Discovery Point, Wollie Creek

Discovery Point, Woll Creek Concept Plan

Building 8 Envelope Parameters

Scale	1:250 @ A1 , 1:500 @ A3		
Drawn	AW	Checked	MA
Project no.	S11191		
Status	PLANNING		
Plot Date	3/06/2013 4:49:26 PM		
Plot File	C:\Temp\masterplan-discovery-111110_Central_WAY.rvt		
Drawing no.	DA3-010	Revision	F

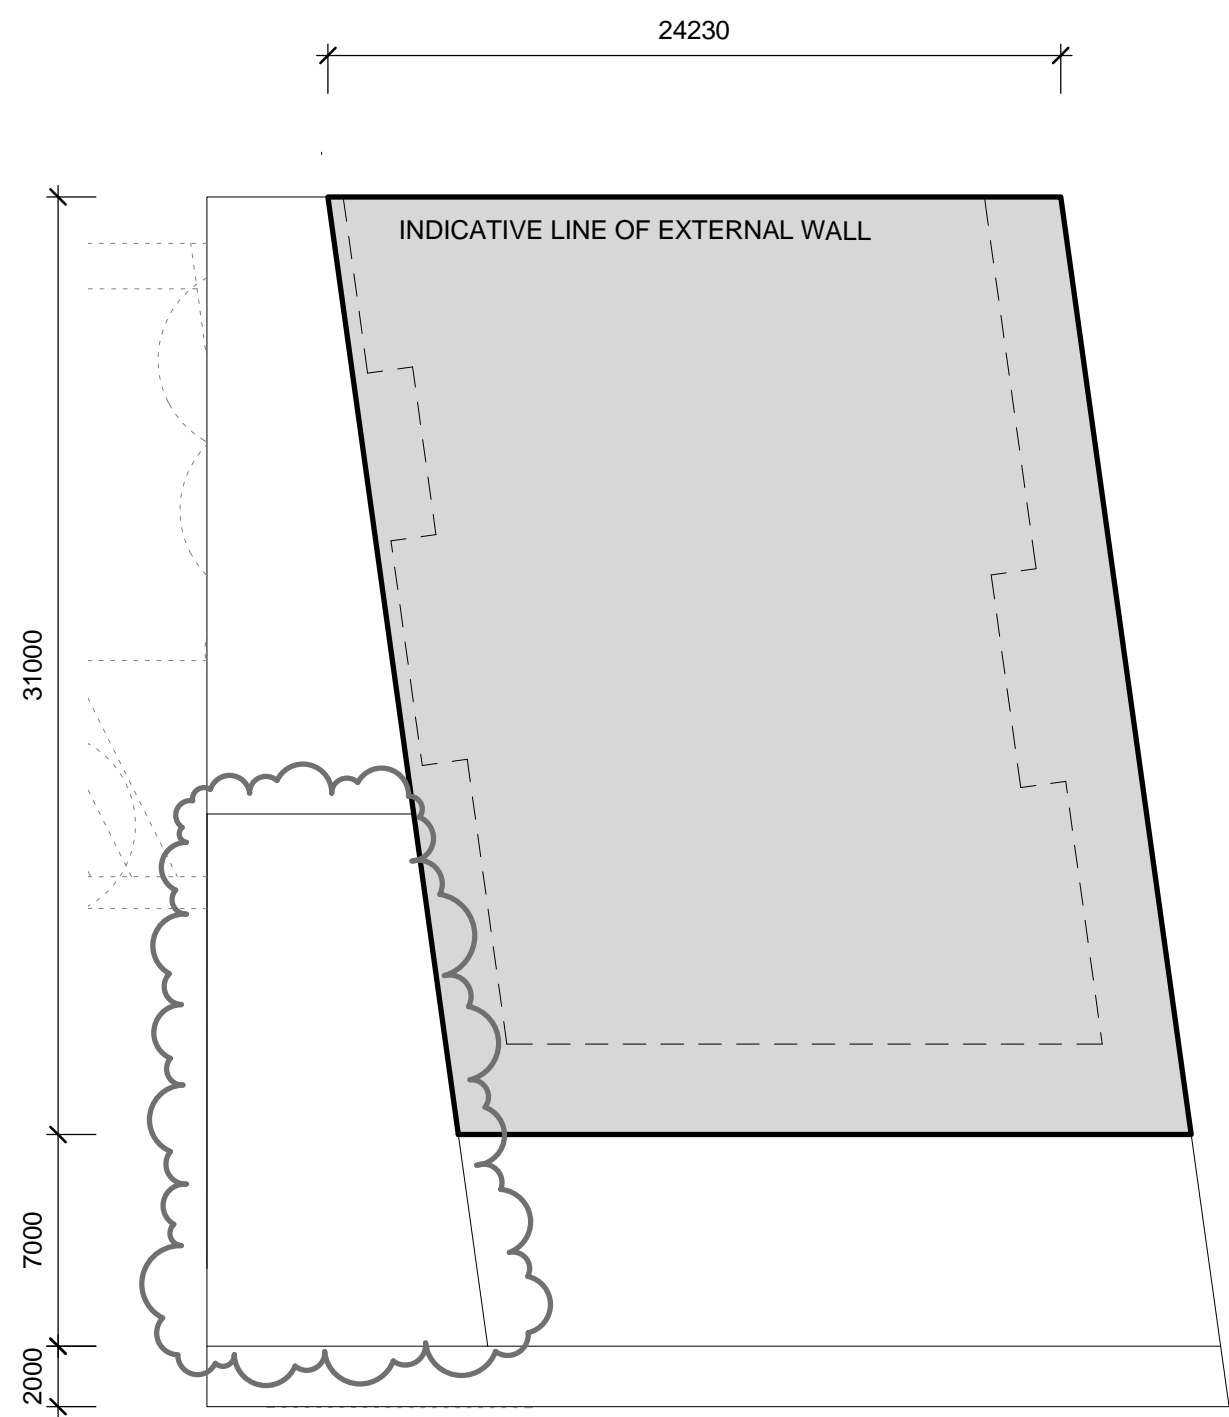
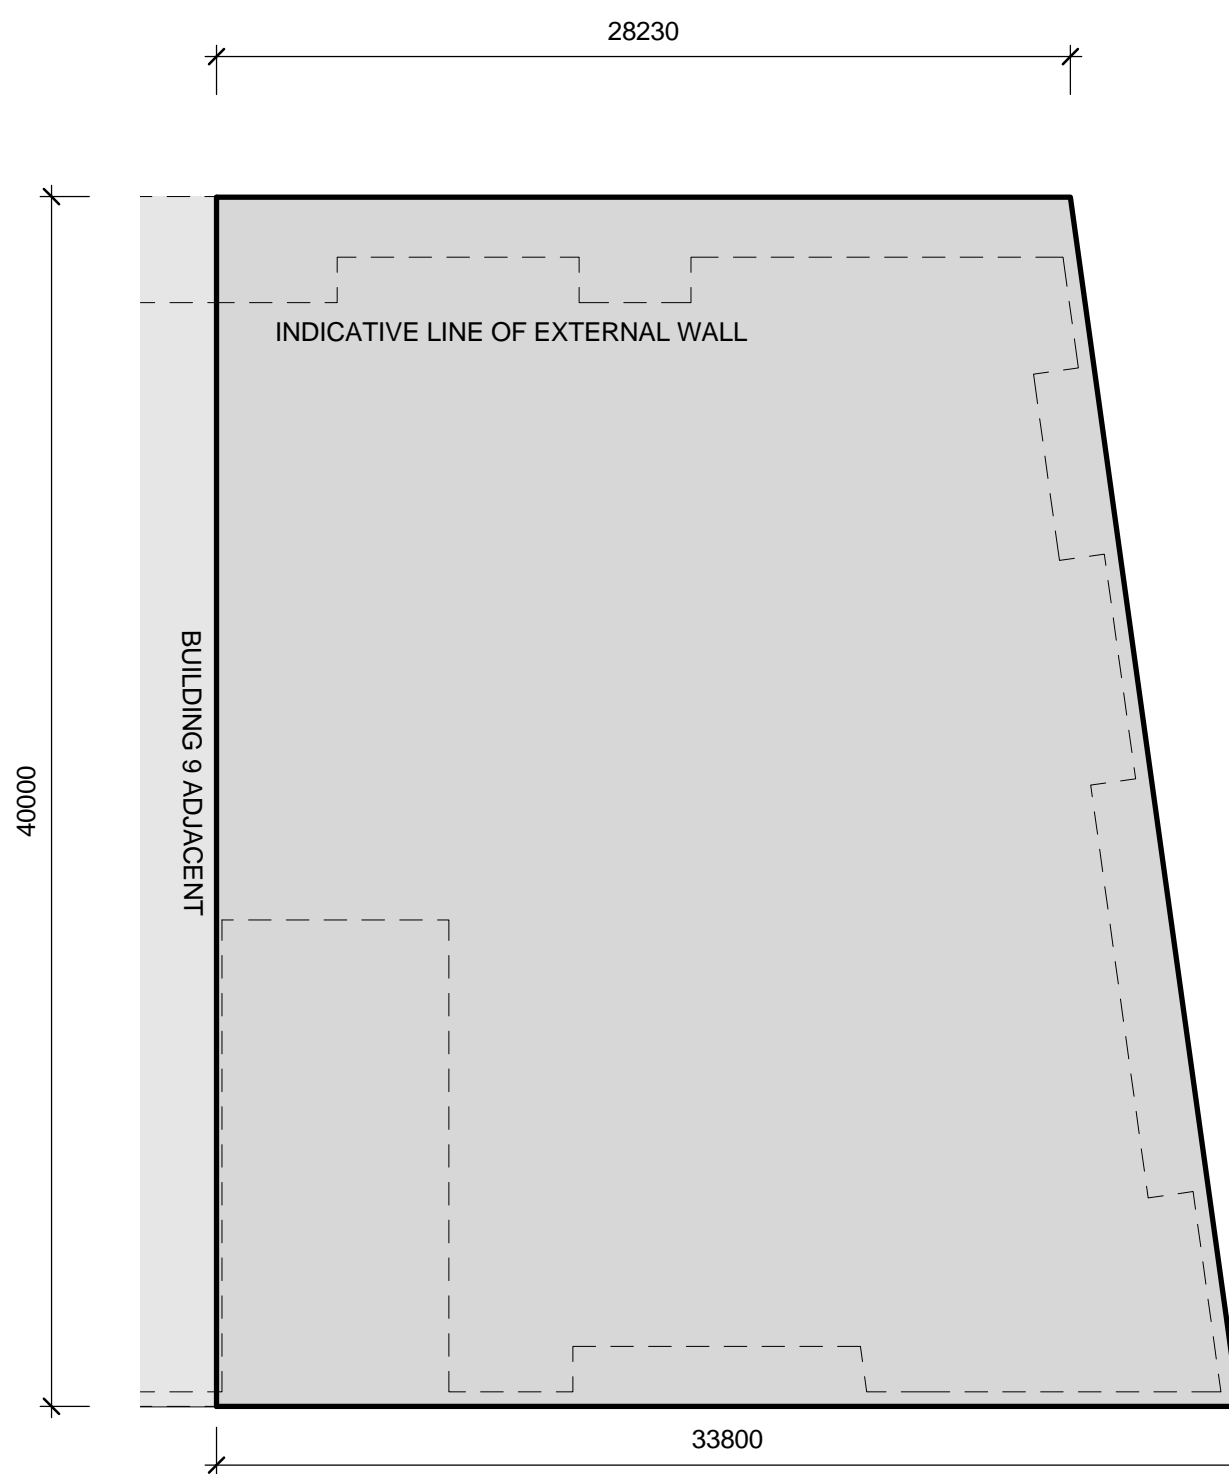
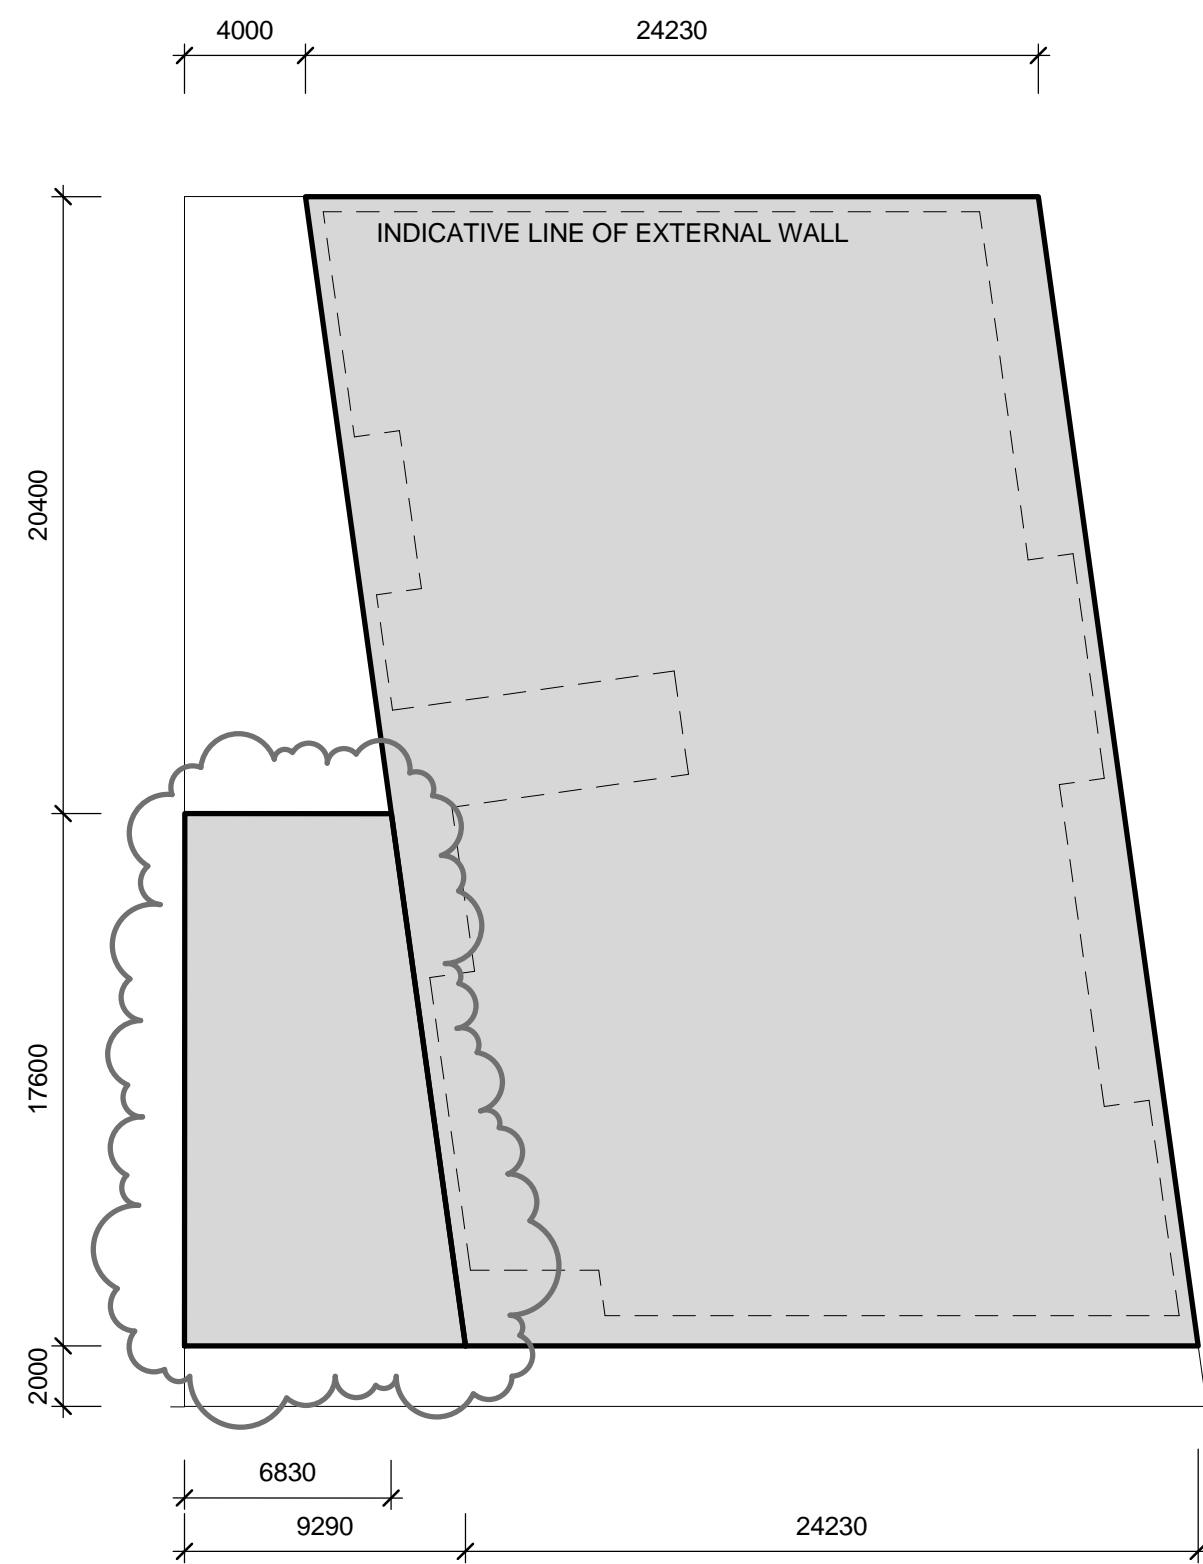
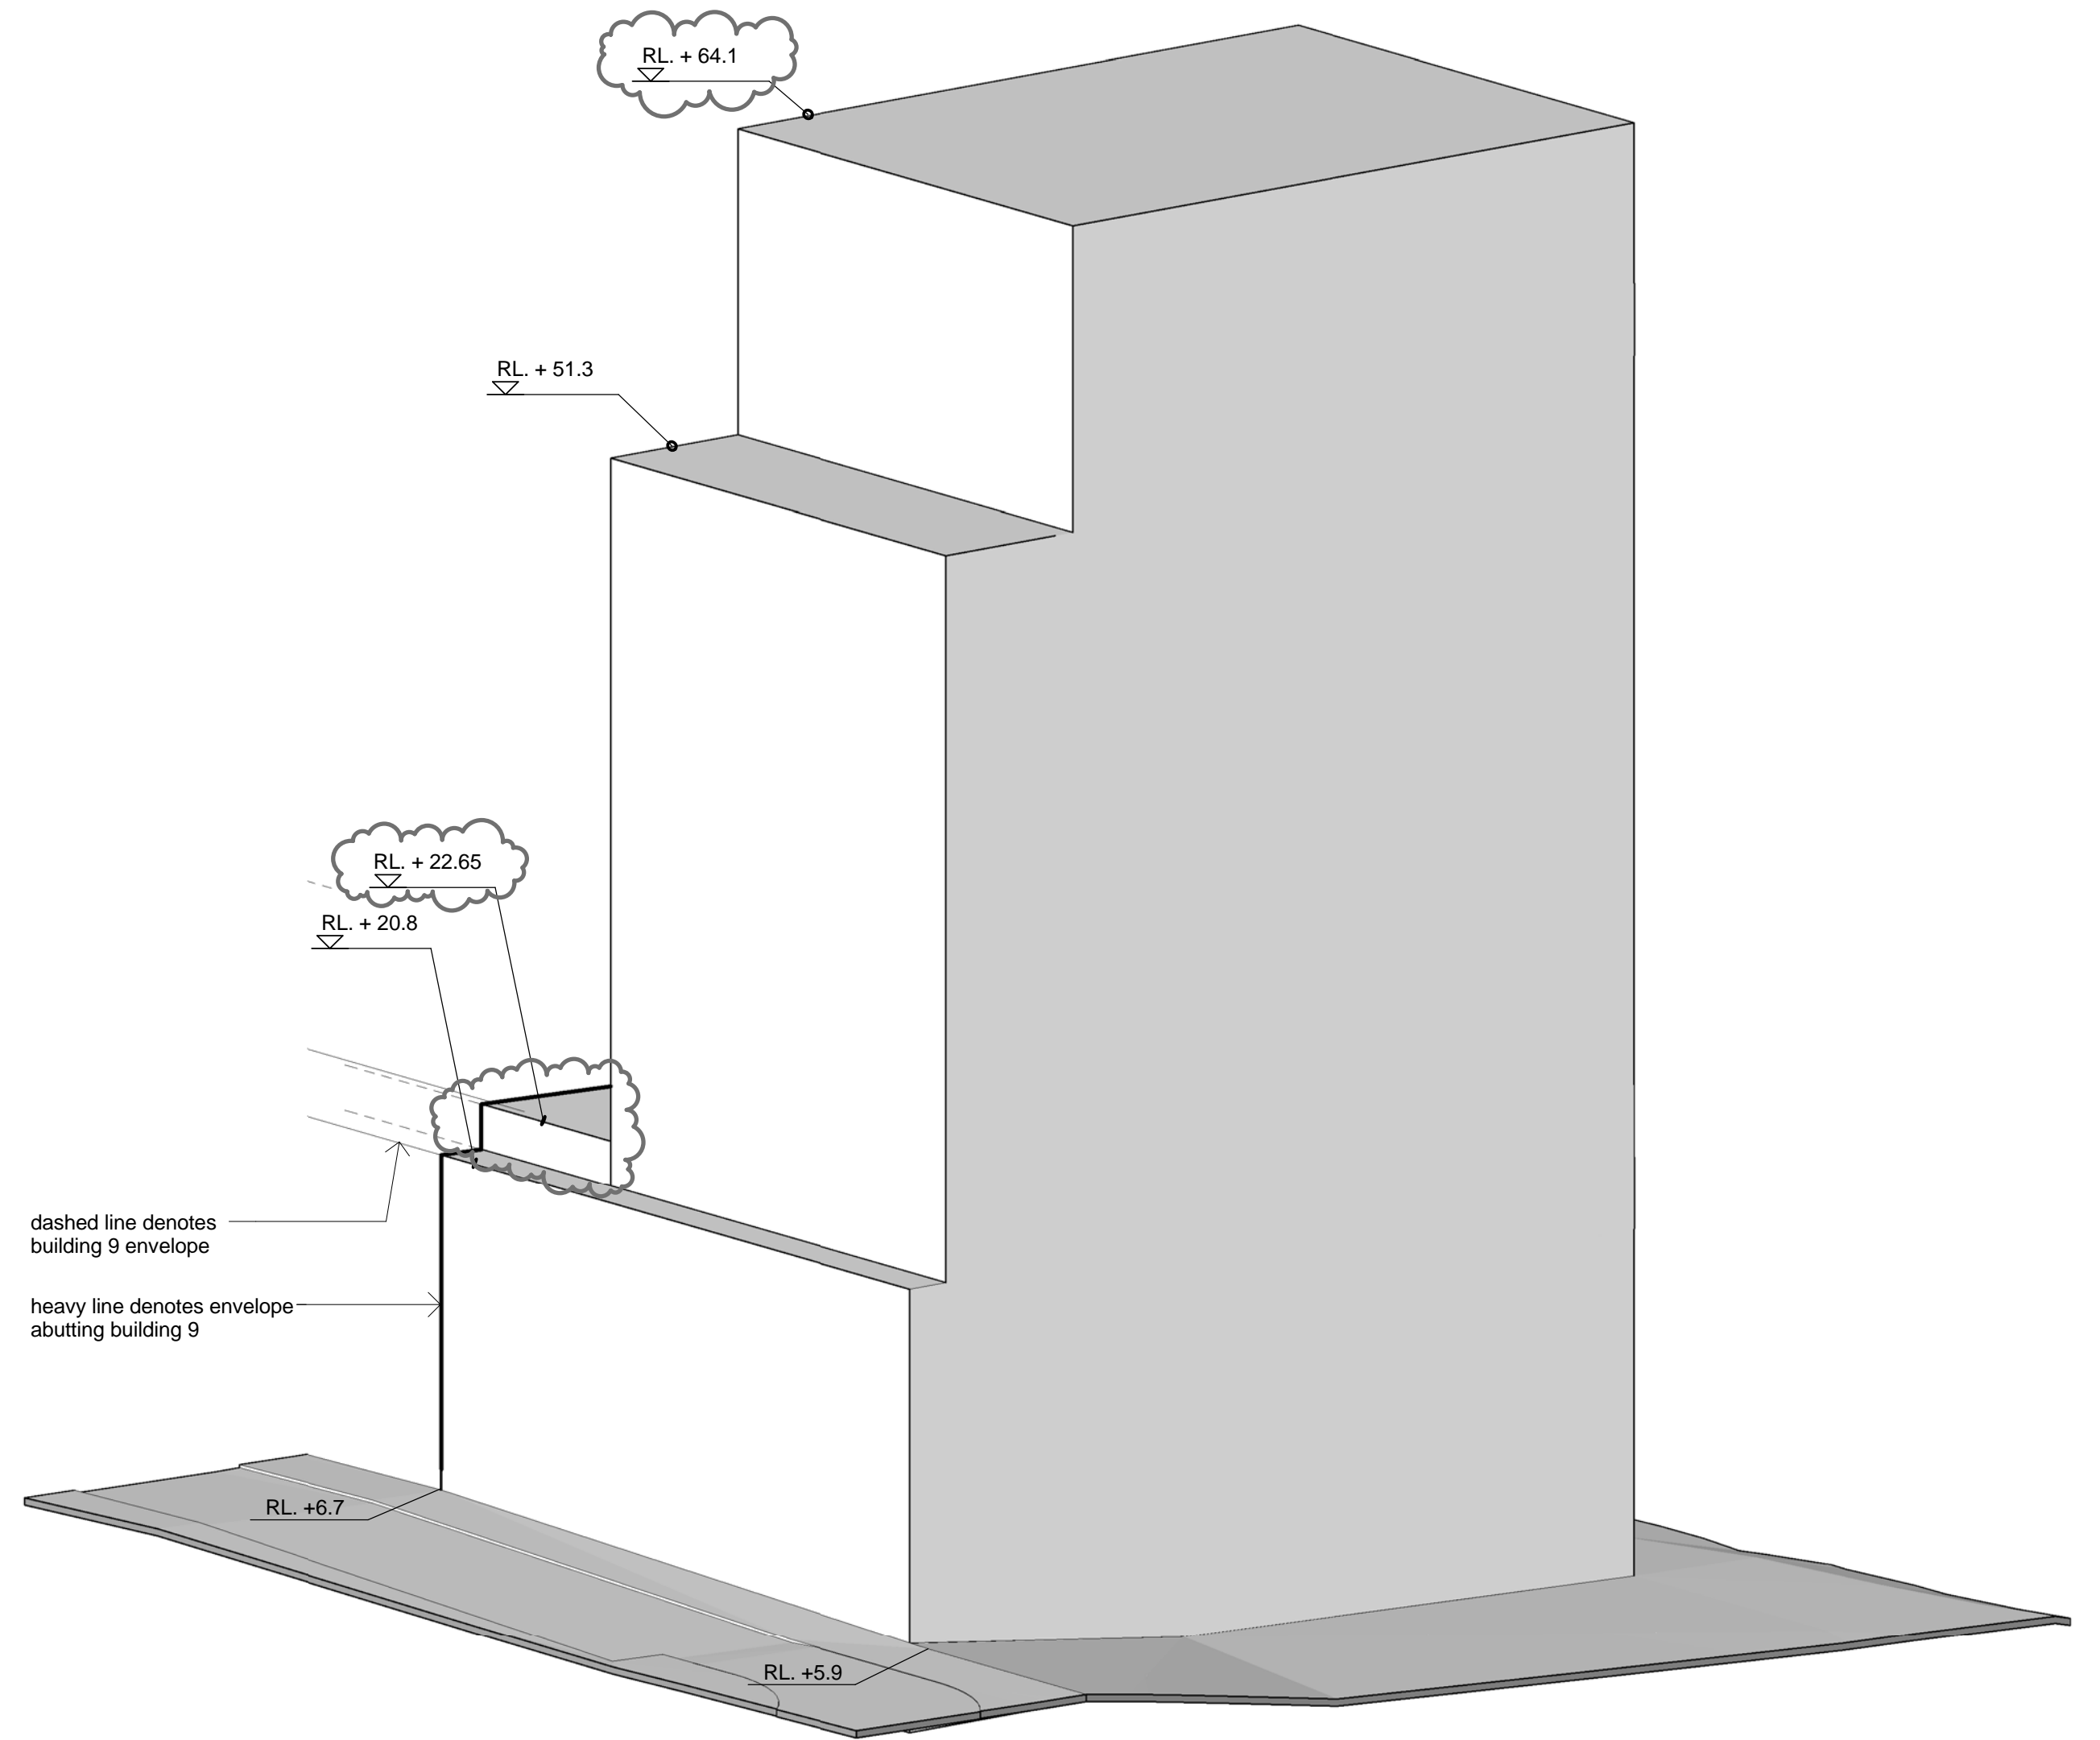
Amendments since Revision A
Envelope reduced at East, West and South to increase building separation
Setback to Cooks River Increased
Typical High Level Plan width amended
